AGENDA
CITY OF STURGEON BAY
CITY PLAN COMMISSION
Monday, September 30, 2019
6:00 p.m.
City Council Chambers
421 Michigan Street, Sturgeon Bay, WI

Staff Report
Planned Unit Development
Sawyer School Lofts

Proposal: Northpointe Development is petitioning for approval of a Planned Unit Development (PUD) for a 40-unit apartment building. The project proposal involves remodeling the privately-owned former West Side Elementary School at 17 W. Pine Street into 11 apartments and the construction of a 3-story addition containing an additional 29 apartments. This addition will extend into the City-owned property containing the West Side Softball Field at 37 W. Redwood Street. These apartments will be affordable units as defined by the Department of Housing and Urban Development (HUD) and rents will be based upon the tenant's income. In addition, the project includes 520 square feet of business incubator space that is proposed to be located in the lower level of the school building.

C1.1

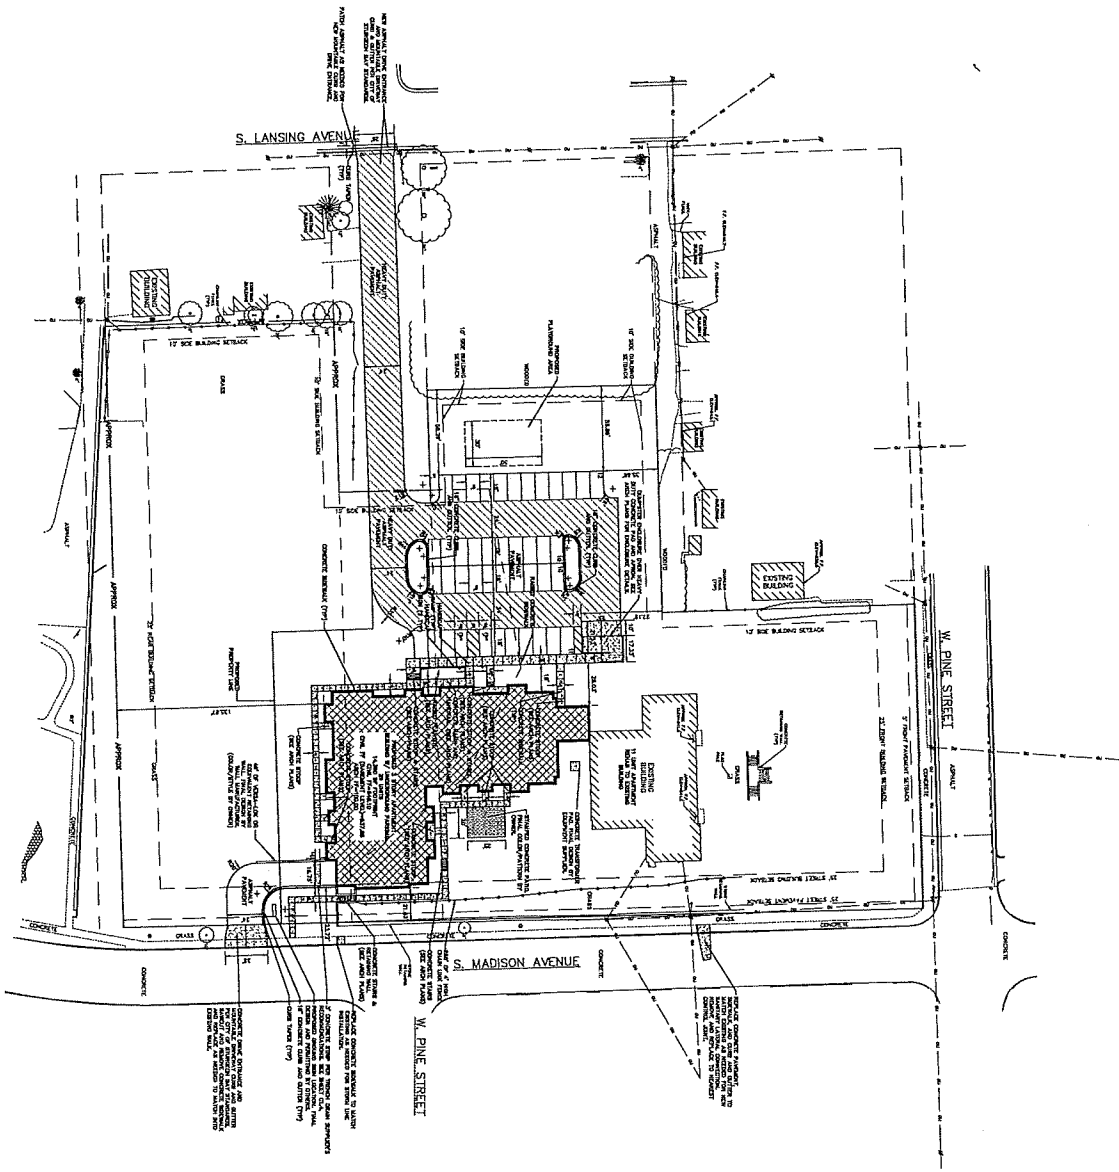
The building meets area and dimensional requirements of the zoning code, except the building will encroach into the normal residential street yard (setback). The required street yard is 25 feet and the building is 21.83 feet from the Madison Ave right-of-way. Staff is supportive of this deviation for two reasons. The Comprehensive Plan designates the site within the Central Business District future land use category. Typically, buildings in the CBD only need to be 15 feet from the right-of-way and the Plan Commission can approve even lesser street yards for downtown buildings. Secondly, the elevation of the proposed building is about ten feet above the grade along Madison Avenue due to the slope/retaining wall. Thus, the benefits of the normal setback from privacy and landscaping standpoints don't apply. If the City is comfortable with the proposed setback, the deviation can be made as part of the PUD ordinance.

Driveway Access: There are two vehicular accesses to the proposed development. The first is via W. Redwood Street, which currently leads to the parking area for the old school. As proposed in the plan all existing pavement will be removed and a new two-lane driveway installed to S. Lansing Avenue. This driveway will be used to access the surface parking. The second access point is a new driveway that will extend off of S. Madison Avenue and lead to the underground parking area. This proposed new driveway has been reviewed by the City Engineer and approved.

It is noted that the existing access into the site from the alley located between Pine and Redwood Streets will be eliminated. The houses abutting the alley would still have vehicular access since the pavement within the alley right-of-way would not be impacted. But the pavement connecting the site to the alley would be removed. The Fire Chief has reviewed and approved the access plan. Also, by eliminating the

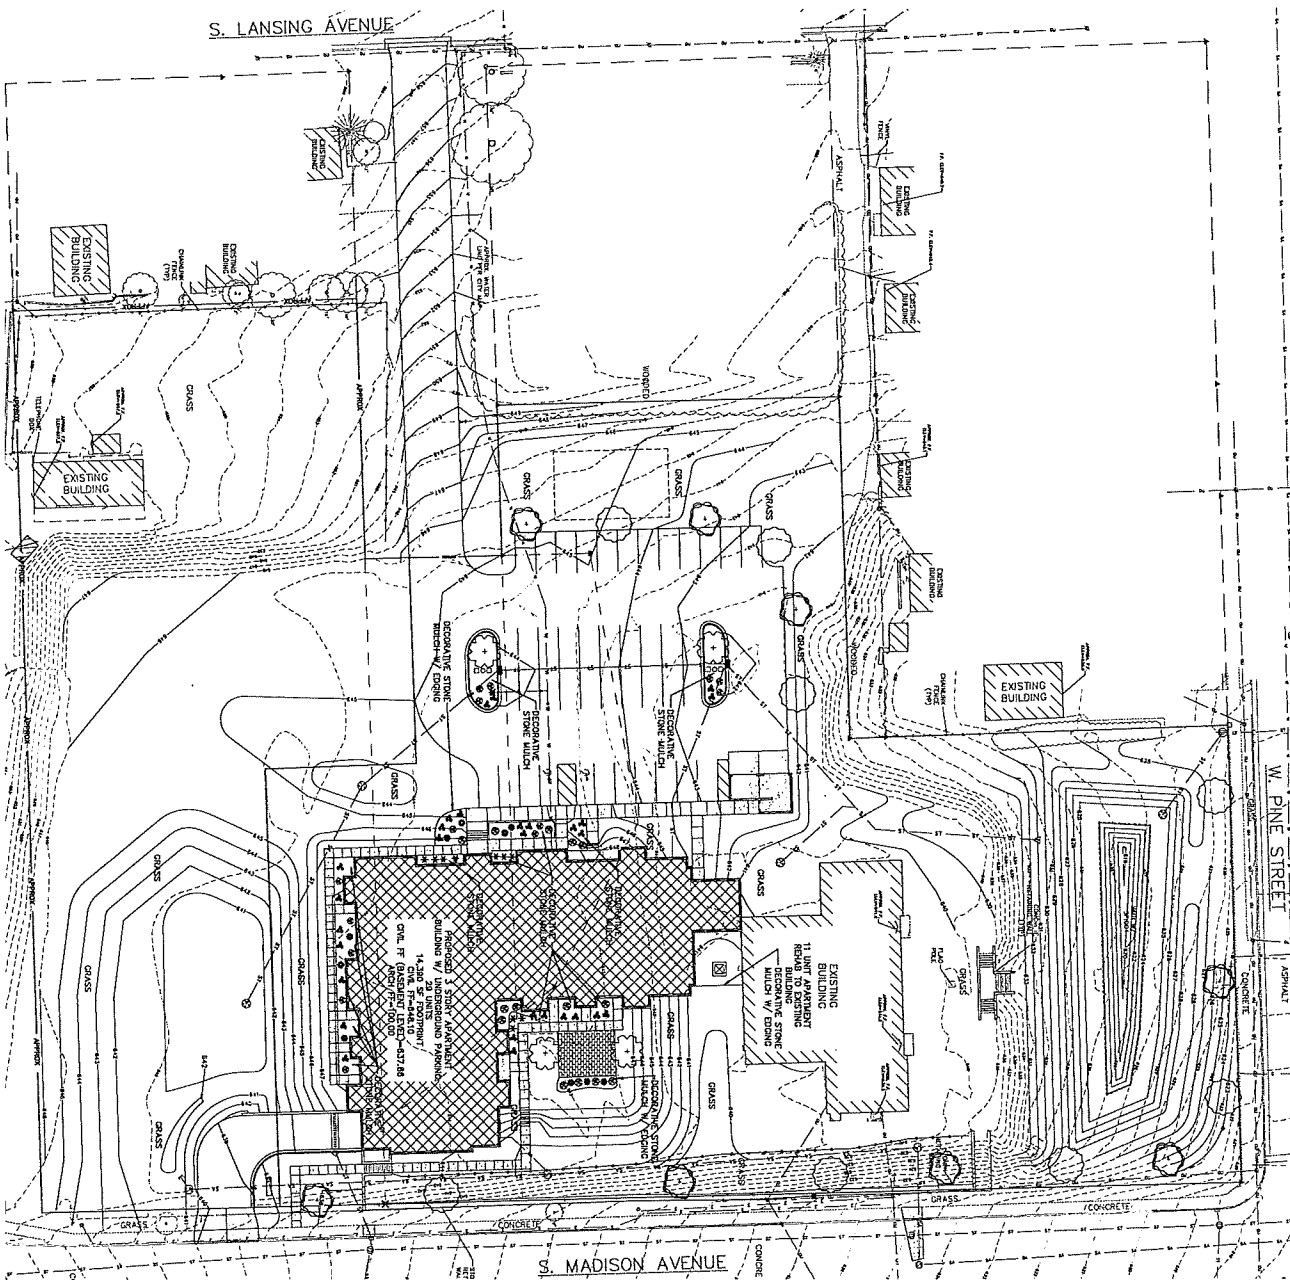
Landscape Design: Off-street parking ordinance requires that one canopy tree be provided for every six parking spaces in the parking lot. The design shows three Skyline Honeylocust and three Redmond Lindon trees planted around the parking lot and two Flowering Crabapple trees planted within the parking lot islands. The zoning administrator is not requiring additional screening from adjacent residential properties around the proposed parking lot due to the grade differential from those adjacent properties. The plan proposes variety of shrubs (Goldmound Spirea, Anthony Waterer Spirea, Taunton Yew, Daylilies, and Hostas) in the landscape islands surrounding the building addition and patio. Two Flowering Crabapples are shown around the patio feature.

Chapter 8 of the Municipal Code requires that a street tree be planted within the tree terrace lawn area for every 50 feet of street frontage. A total of ten trees would typically be required along Madison Avenue and four along Pine Street. There are two existing trees in the right-of-way along Madison Avenue. The landscape plan shows seven Honey Locust and Linden trees planted along the steep slope just outside of the right-of-way. It also shows three trees along Pine Street, also outside of the right-of-way. For Pine Street the location of the trees is appropriate due to the narrowness of the terrace lawn and the overhead wires on that street. For Madison Avenue, it would be preferred to put the new trees within the right-of-way, if possible. Ultimately, these tree locations and varieties need to be approved by the City Forester.
